## SUBMITTAL RESPONSE

PROJECT NAME : PSE OTC

Item :	Joist & Metal Deck Shop Drawings
--------	----------------------------------

**PSE TRAINING CENTER PUYALLUP**  
 PUYALLUP, WA  
 PENNON CONSTRUCTION COMPANY INC.  
 GENERAL CONTRACTOR  
 SEI JOB NO: 43423

# ROOF FRAMING PLAN- NORTH

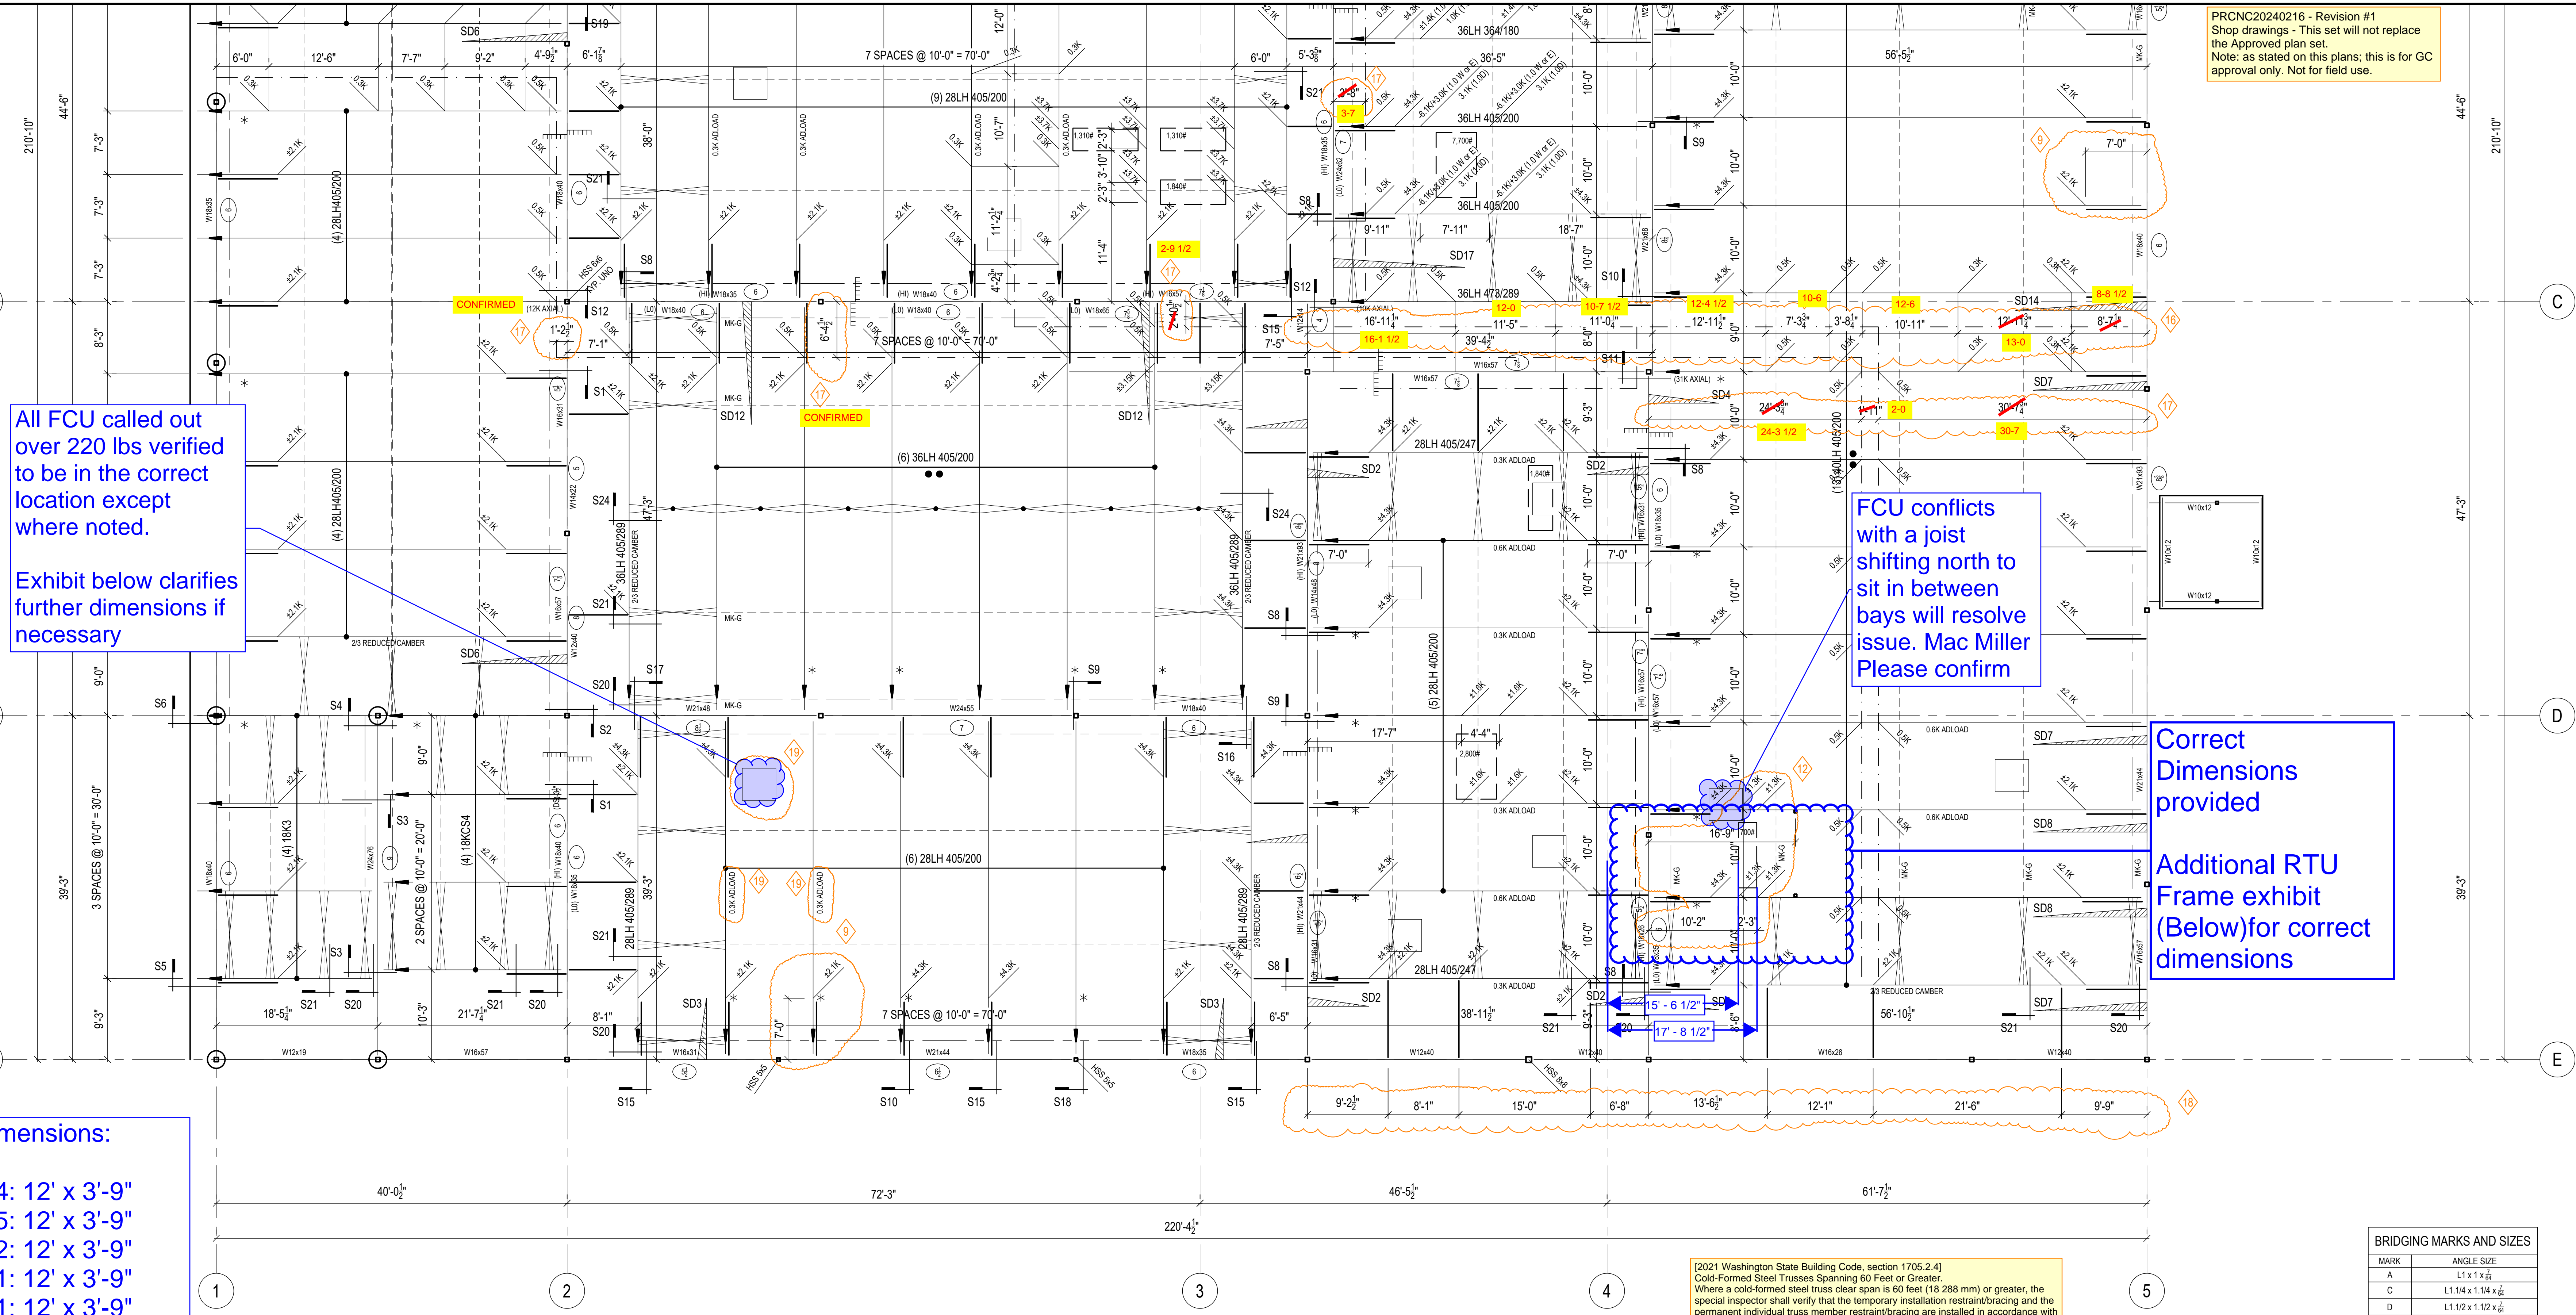
- 4 PLEASE VERIFY 7'-0" DIMENSION FROM GRIDS TO UP/DOWN LOAD DUE TO BRACING. IF THESE ARE OUGHT TO BE LOCATED AT FIRST PANEL POINT OR CLOSE TO IT, THE 7'-0" WOULD BE THE APPROXIMATED LOCATION. PANEL POINTS ARE NOT AVAILABLE UNTIL JOIST CONFIGURATION IS PREPARED AT FABRICATION TIME. **Acceptable per DL.**

- 5 PLEASE VERIFY UP/DOWN LOADS LOCATION FROM GRID C AS SHOWN. DIMENSIONS WERE SCALED FROM STEEL APPROVAL DRAWINGS. IF THESE ARE NOT CORRECT PLEASE PROVIDE SPECIFIC LOCATIONS. **Pennon will scale steel drawings back check EOR drawings to confirm locations. Design team to confirm Pennons approval/review.**

- 15 PLEASE VERIFY BRACING LOCATION FROM GRIDS A AND GRIDS 4 & 5 AS SHOWN. SOME DIMENSIONS WERE SCALED FROM STEEL APPROVAL DRAWINGS. IF THESE ARE NOT CORRECT, PLEASE PROVIDE SPECIFIC LOCATIONS. **DL to confirm locations**

- 16 PLEASE VERIFY LOADS LOCATIONS DUE TO SPRINKLERS HANGERS AND/OR CLAMPS ON JOISTS AS SHOWN. DIMENSIONS SHOWN WERE SCALED FROM PSE OTC-FP1 PLANS PROVIDED. IF THESE ARE NOT CORRECT PLEASE PROVIDE SPECIFIC LOCATIONS. **Run to confirm scale before lunch tomorrow.**

All FCU called out over 220 lbs verified to be in the correct location, Exhibit below clarifies further dimensions if necessary

Correct Dimensions provided  
 Additional RTU Frame exhibit (Below) for correct dimensions

1 ROOF FRAMING PLAN - SOUTH  
1/8" = 1'-0"

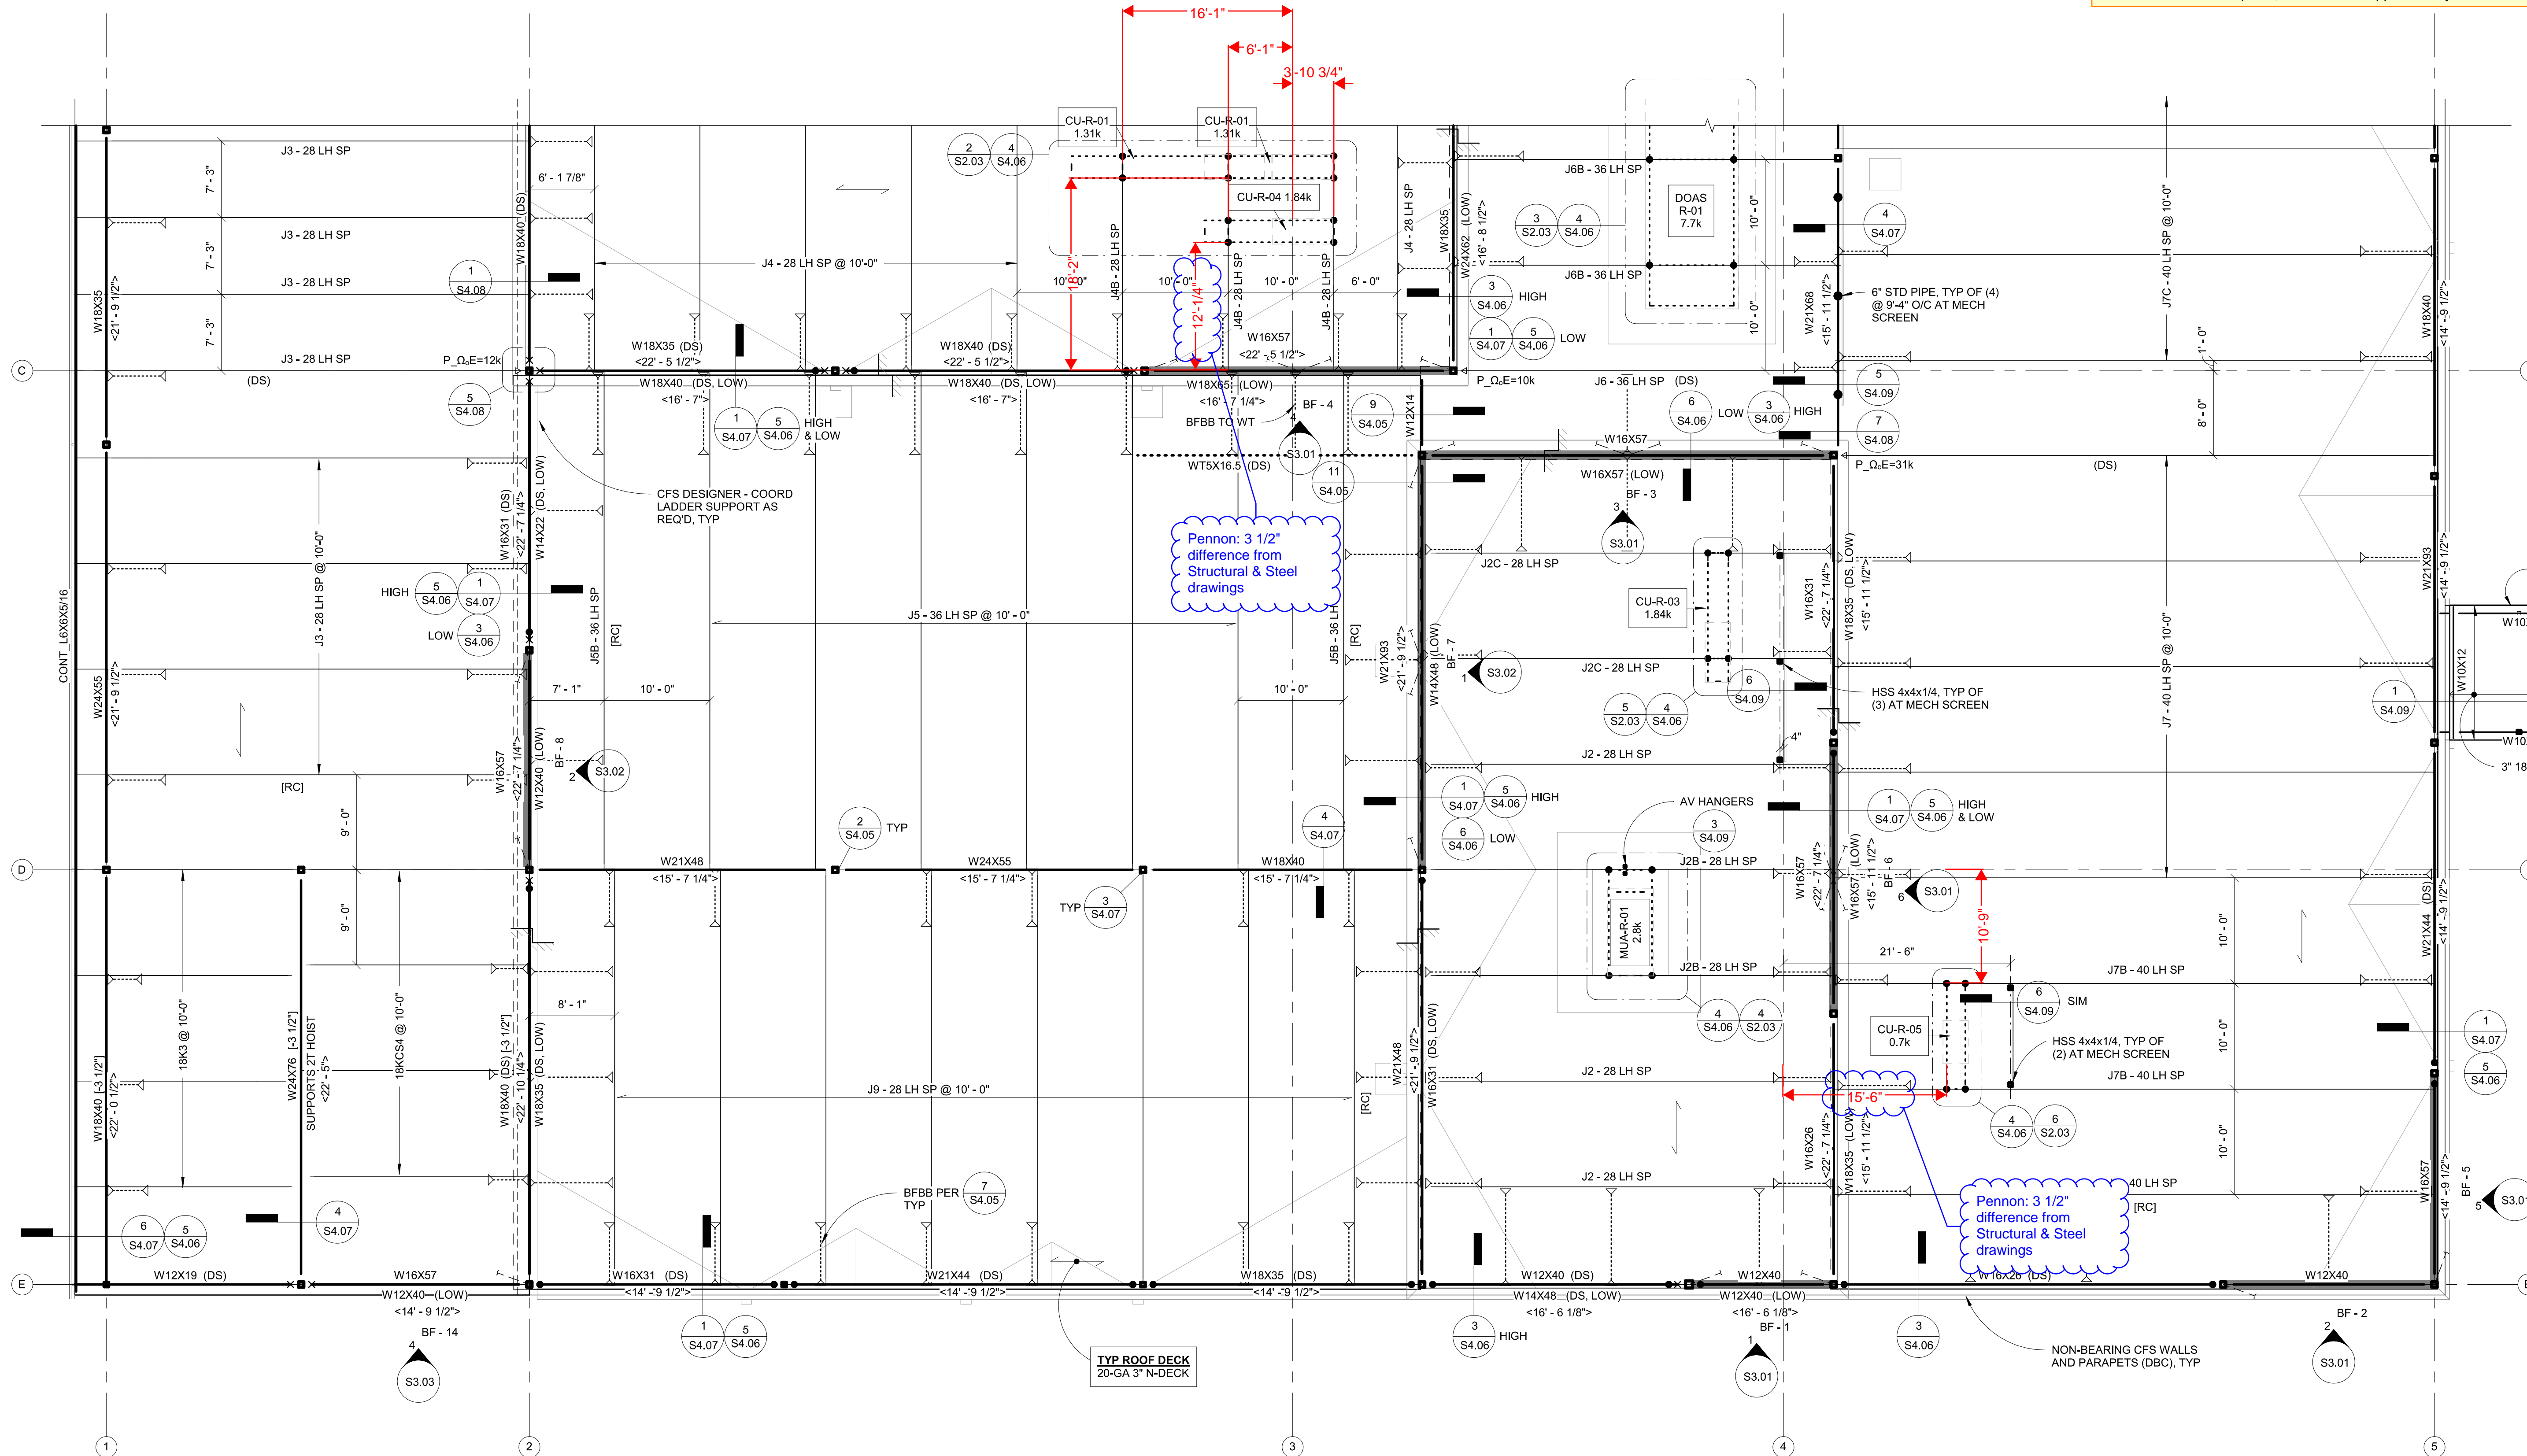
- (KW 7/10/24) No objections → 16 PLEASE VERIFY 7'-0" DIMENSION FROM GRIDS TO UP/DOWN LOAD DUE TO BRACING. IF THESE ARE OUGHT TO BE LOCATED AT FIRST PANEL POINT OR CLOSE TO IT, THE 7'-0" WOULD BE THE APPROXIMATED LOCATION. PANEL POINTS ARE NOT AVAILABLE UNTIL JOIST CONFIGURATION IS PREPARED AT FABRICATION TIME.

- (KW 7/10/24) Pennon to coordinate with steel shops → 12 PLEASE VERIFY UP/DOWN LOADS LOCATION FROM GRID C AS SHOWN. DIMENSIONS WERE SCALED FROM STEEL APPROVAL DRAWINGS. IF THESE ARE NOT CORRECT PLEASE PROVIDE SPECIFIC LOCATIONS.

- (KW 7/10/24) Pennon/Patriot to confirm → 16 PLEASE VERIFY LOADS LOCATIONS DUE TO SPRINKLERS HANGERS AND/OR CLAMPS ON JOISTS AS SHOWN DIMENSIONS SHOWN WERE SCALED FROM PSE OTC-FP1 PLANS PROVIDED. IF THESE ARE NOT CORRECT PLEASE PROVIDE SPECIFIC LOCATIONS.

- (KW 7/10/24) Pennon/Patriot to confirm → 17 PLEASE VERIFY CLOUDED LOCATIONS FOR SPRINKLERS LINES CENTERLINE, CLAMPED ON JOISTS AND IN ORDER TO LOCATE LOADS ACCORDINGLY. VERIFY AND/OR PROVIDE LOCATIONS FROM GRIDS 2, C, 0, 4 & 5 AND OFF GRID 3 AS SHOWN. THESE LOCATIONS WERE SCALED FROM PSE OTC-FP1 PLANS PROVIDED. IF THESE ARE NOT CORRECT PLEASE PROVIDE SPECIFIC LOCATIONS.

- (KW 7/10/24) No objections → 18 PLEASE VERIFY BRACING LOCATION FROM GRID 5 AS SHOWN. THESE LOCATIONS WERE SCALED FROM STEEL APPROVAL DRAWINGS. IF THESE ARE NOT CORRECT, PLEASE PROVIDE SPECIFIC LOCATIONS.

- (KW 7/10/24) No objections to addnotes shown → 19 PLEASE VERIFY LOCATIONS FOR FCU HUNG UNITS AND JOISTS INVOLVED WITH NEW ADD LOAD OF 0.3K AS SHOWN (TYP.). PROVIDE OTHERWISE.

Ron to confirm scale before lunch tomorrow.

Ron to confirm scale before lunch tomorrow. All hangers connect to top cords, per RS

DL to confirm locations
